Builder: Delpark Homes
Project: The Ross
Location: Oshawa, ON.
Type: T8 Corner Kingsbridge 4

Option 1,2,4,5

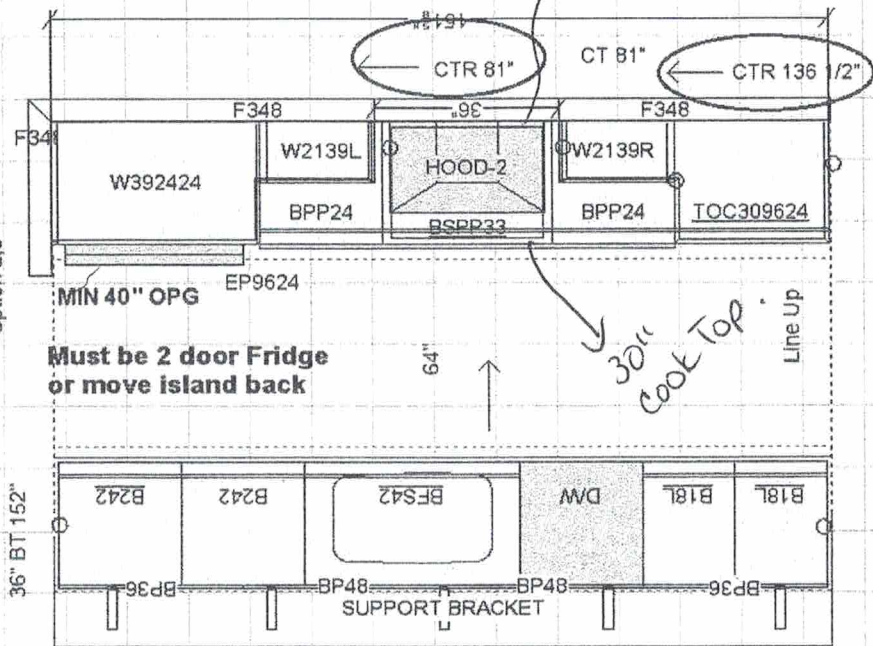
Must be 2 door Fridge
or move island back

Line Up

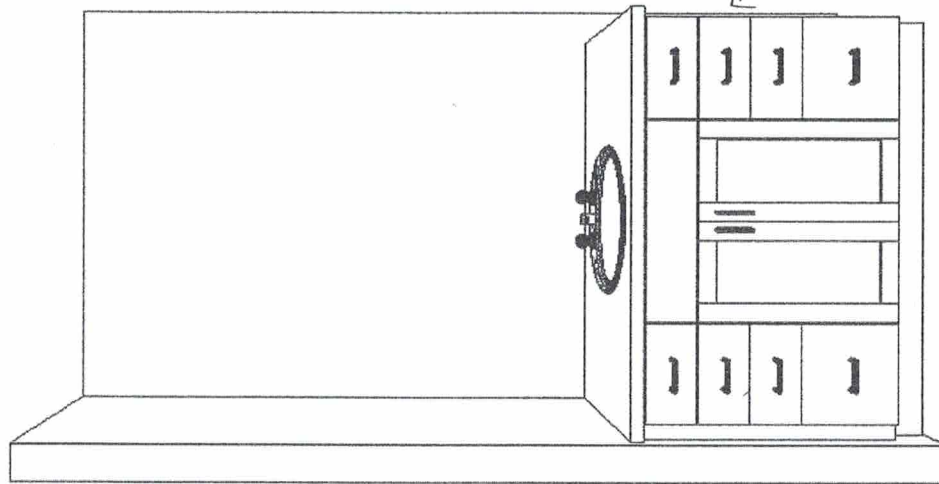
We don't have a 3
drawer vanity in the
taller height, unless
you use a pot pan
cabinet and change the
depth, which I can do

Also let me know if you
want the drawer fronts
to match the doors,
instead of a slab like
the picture shows

Also had to extend this
by 3" to get the 2 doors
in the middle. The
smallest bank of
drawers is 12", and the
smallest 2 door cabinet
is 24", so that uses 48"
and I still need a filler
at the wall and
overhang on the
counter, so I am using
50 1/2" - 51"
depending on door
trim thickness.

Match to doors
not slab.
not slab
e-mail 9/11/19
